Resubmittal of Electrical Door and Panel per 064116-003 Detail 3/7.

WEBSTER UNIVERSITY ISB
PROJECT NAME

PROJECT: 15051-Webster University Interdisciplinary Science Building

RE: plastic laminate faced architectural cabinets shop drawings

1/01 Elevation at Electrical
3/8"= 1'-0"

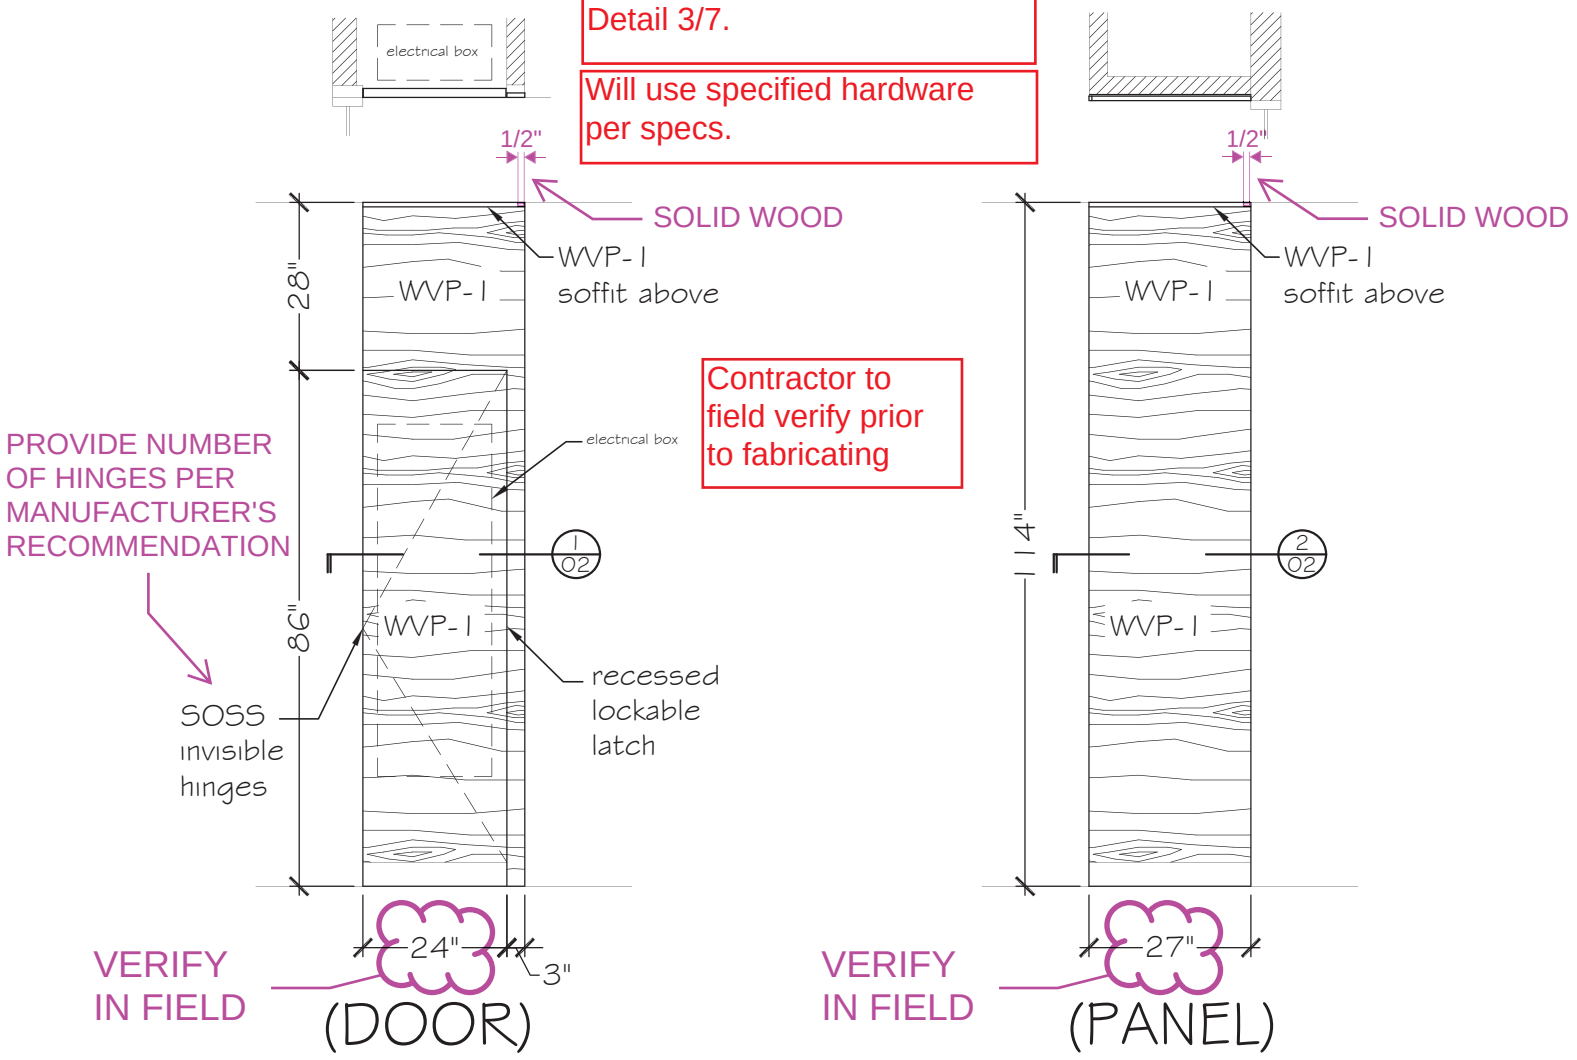
PROVIDE IDENTIFIED/ HIGHLIGHT LOCATIONS ON PLAN
- TO CONFIRM JOINTS & DEPTH (FOR EG. AT TOILET ENTRY).

Will use specified hardware per specs.

3 / 04 Plan and Elevation at Pocket Door
3/8"= 1'-0"

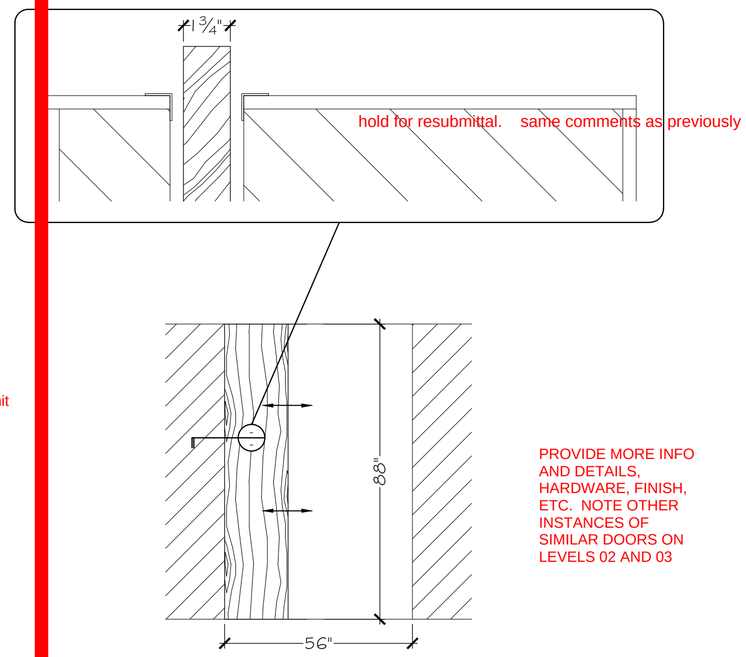
PROVIDE MORE INFO AND DETAILS, HARDWARE, FINISH, ETC. NOTE OTHER INSTANCES OF SIMILAR DOORS ON LEVELS 02 AND 03

4 / 04 Elevation at Paneling 1st Floor
3/8"= 1'-0"

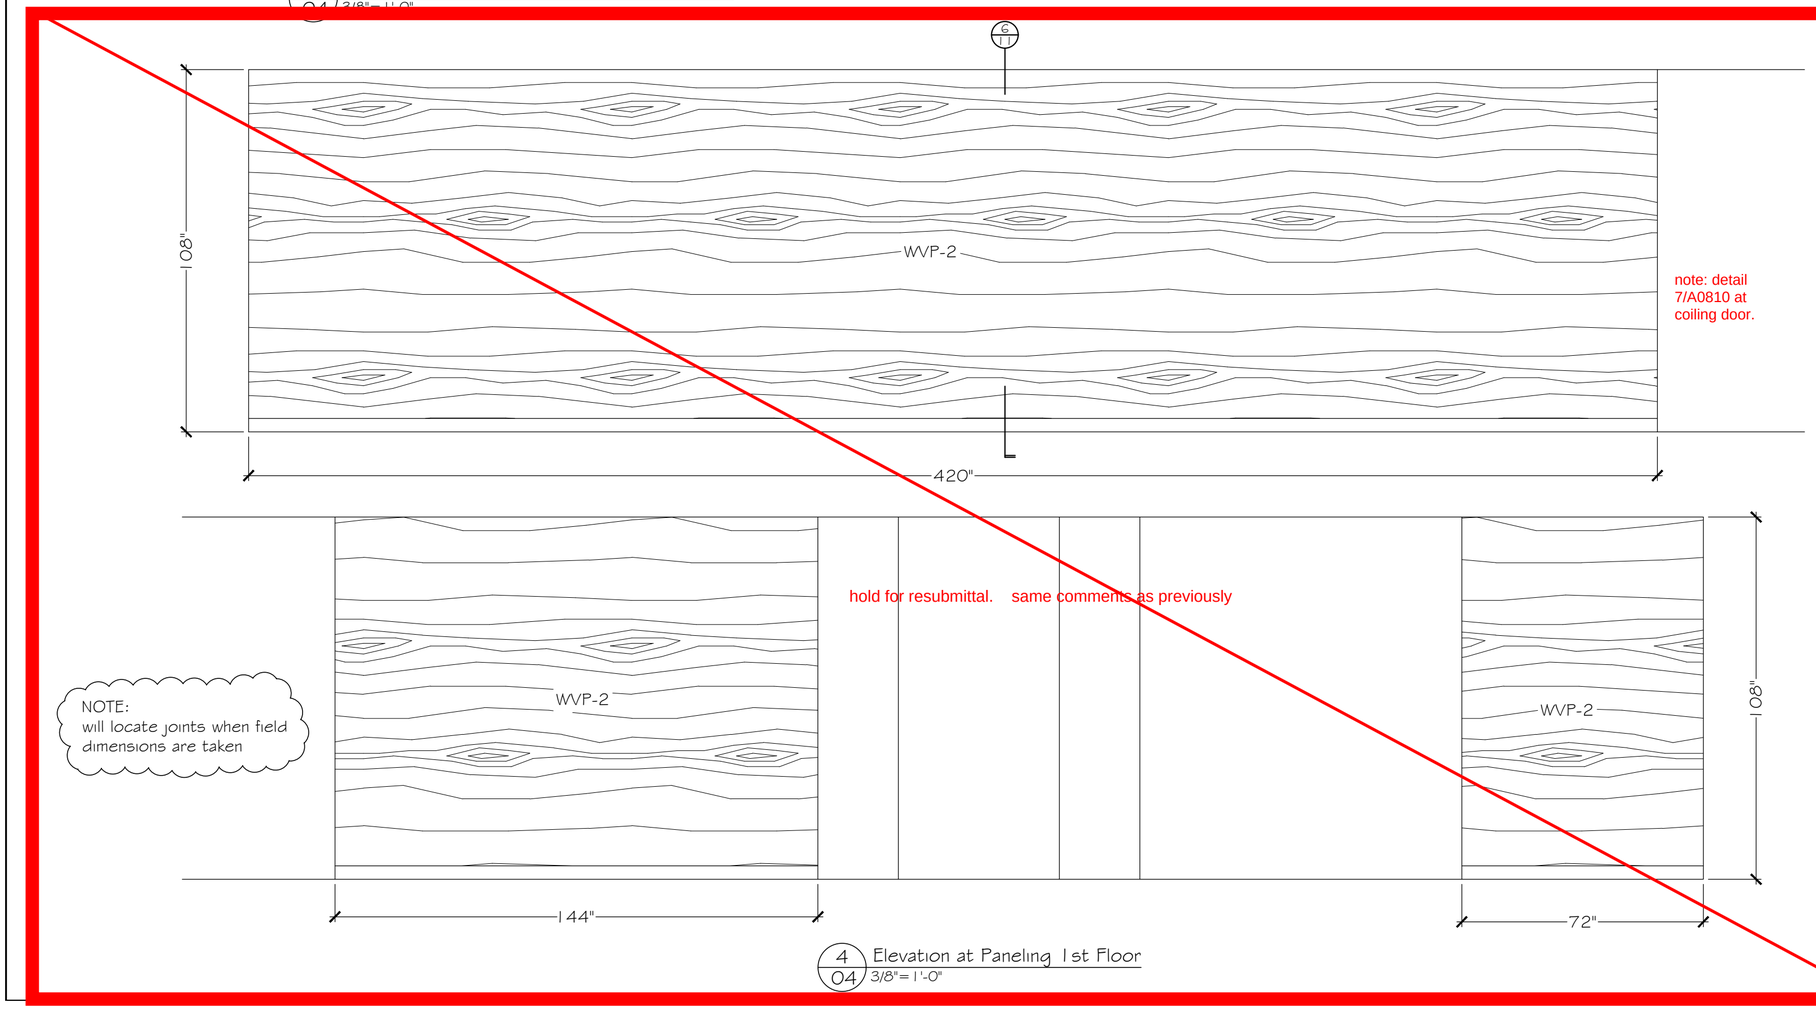
hold for resubmittal. same comments as previously

1/06 Elevation at Paneling 4th Floor
3/8"=1'-0"

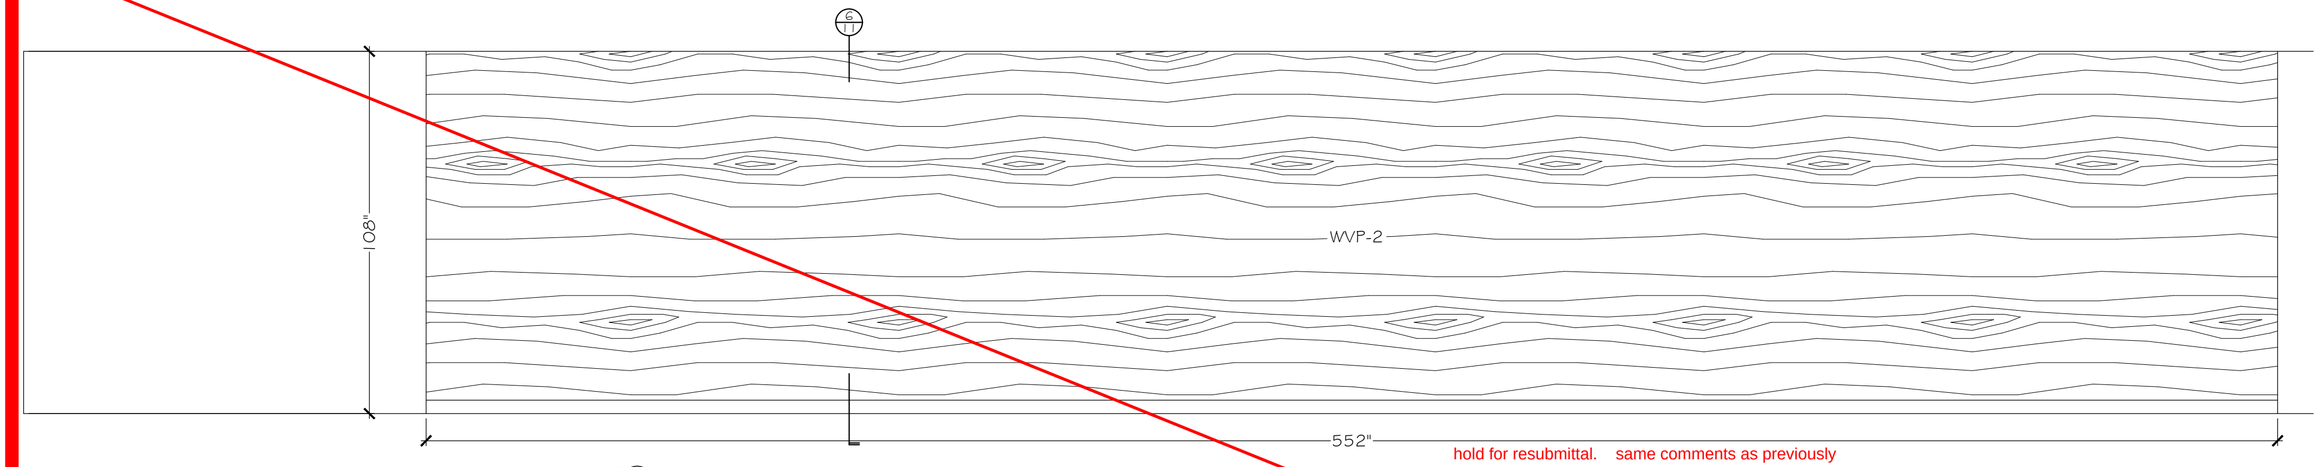
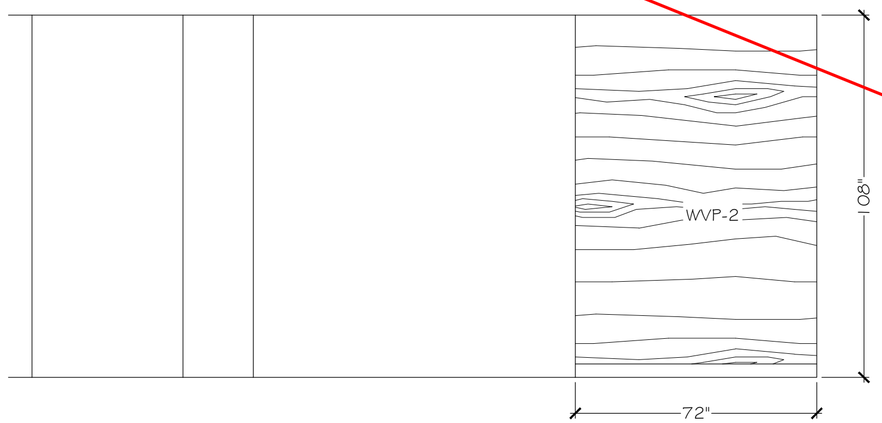
not reviewed. provide full scope of wood soffit and jamb panels.

Resubmit & Provide plan locations, and all details.
Identify both locations - electrical panels with doors and fixed panel.

Note: Whenever there are soffit panels. They should match & fit to wall panels.

NOTE:
will locate joints when field dimensions are taken

2/07 Elevation at Panels in Stairwells
3/8"=1'-0"

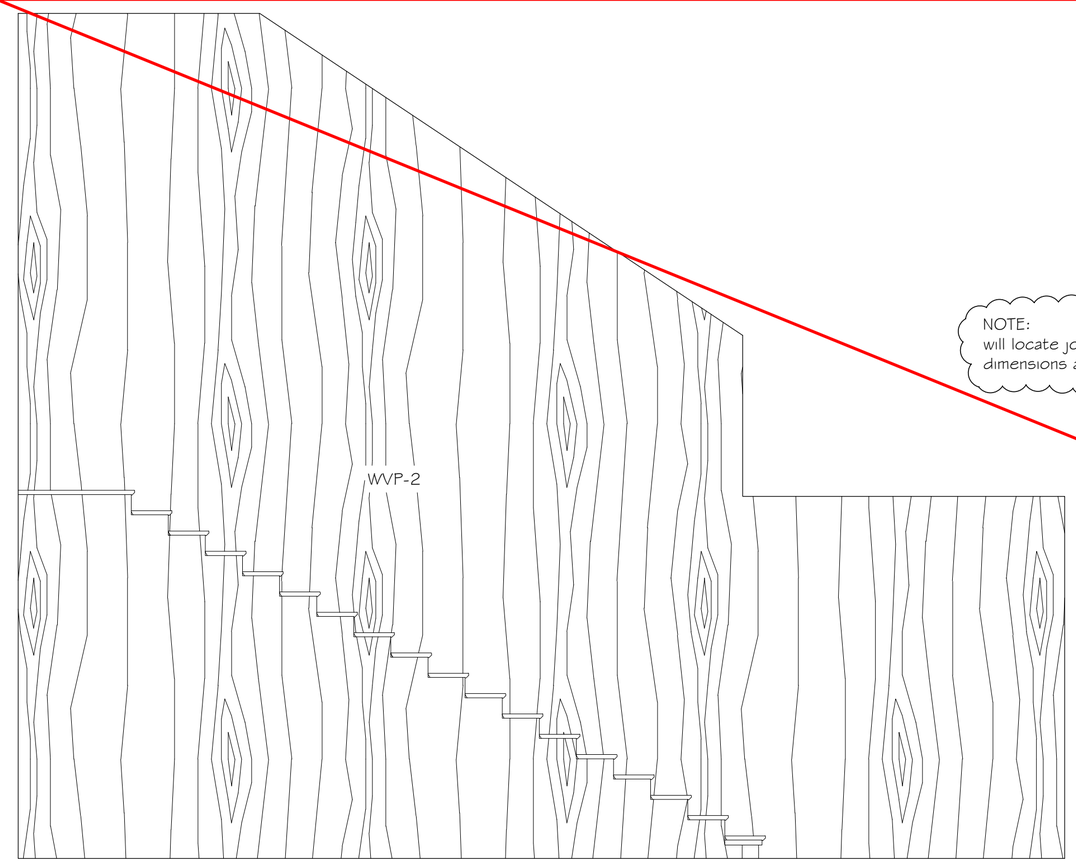
hold for resubmittal. same comments as previously

NOTE:
will locate joints when field dimensions are taken

4/07 Plan and Elevation at Toilet Rooms
3/8"=1'-0"
177 / 179 / 277 / 279 / 377 / 379 / 477 / 479

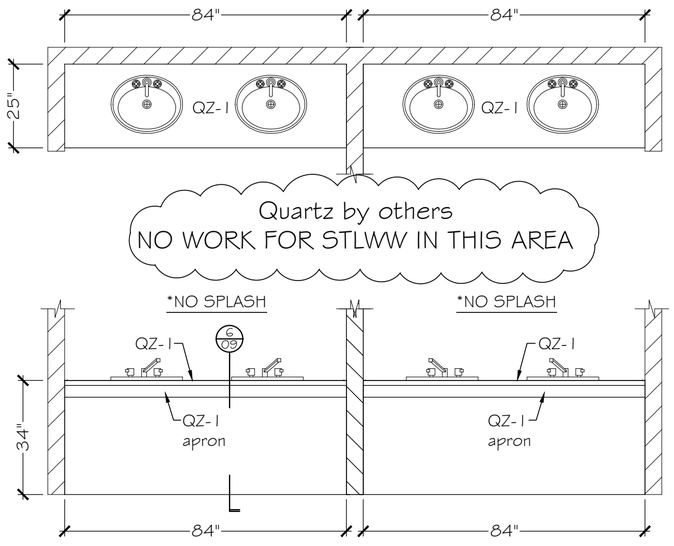
hold for resubmittal. same comments as previously

4/01 Plan and Elevation at K'ETTE Rooms
3/8"=1'-0"
100C / 200C / 300C / 400C

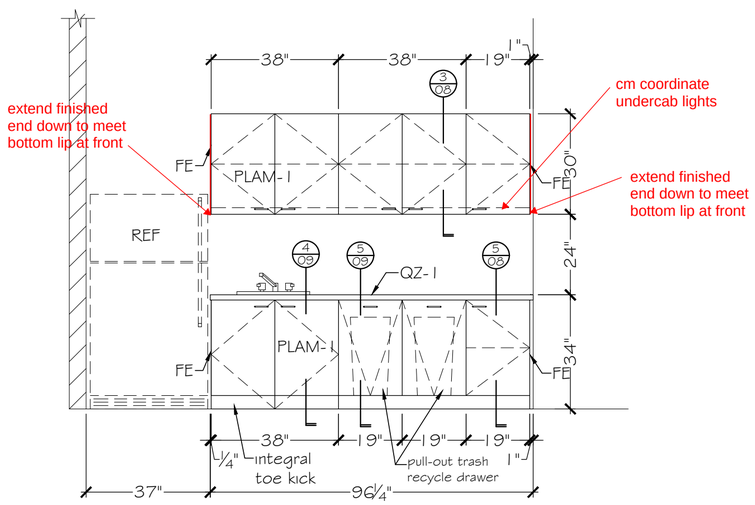
indicate laminate grades and locations. indicate pvc banding / provide samples note: white melamine acceptable at "semiexposed" surfaces

Not acceptable: provide per specification for drawer width and depth

4 / 04 Elevation at Paneling 1st Floor
3/8"= 1'-0"

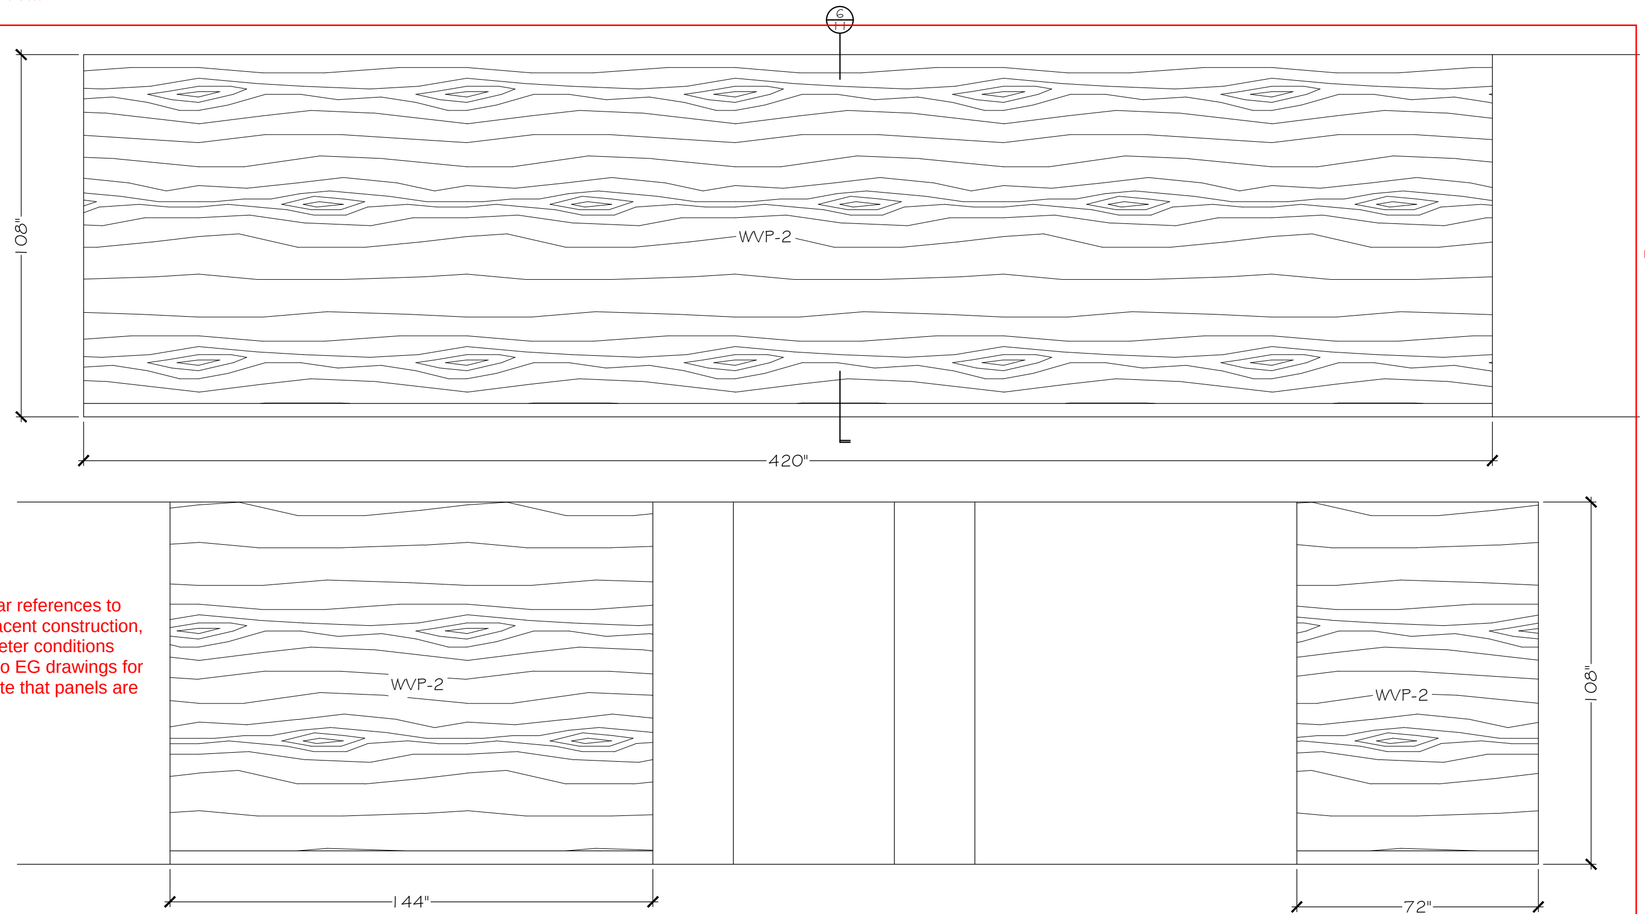
Show joints show clear references to column lines and adjacent construction, show details at perimeter conditions and at joints. Refer to EG drawings for jointing locations. Note that panels are opaque wood finish.

1/05 Elevation at Paneling 2nd Floor
3/8"= 1'-0"

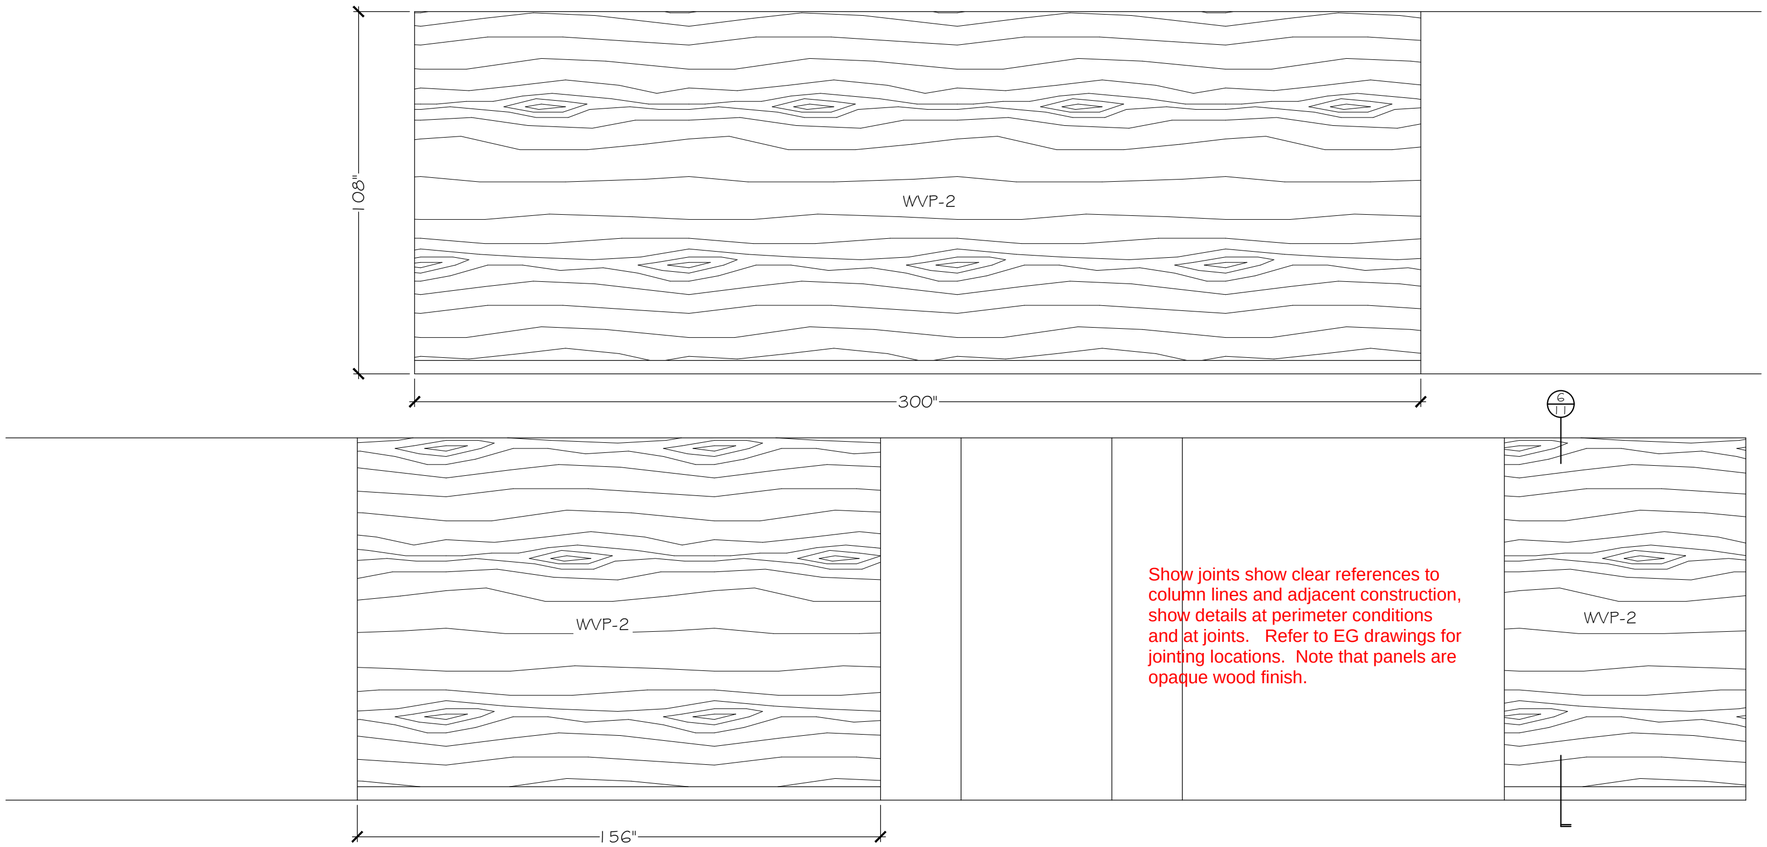
Show joints show clear references to column lines and adjacent construction, show details at perimeter conditions and at joints. Refer to EG drawings for jointing locations. Note that panels are opaque wood finish.
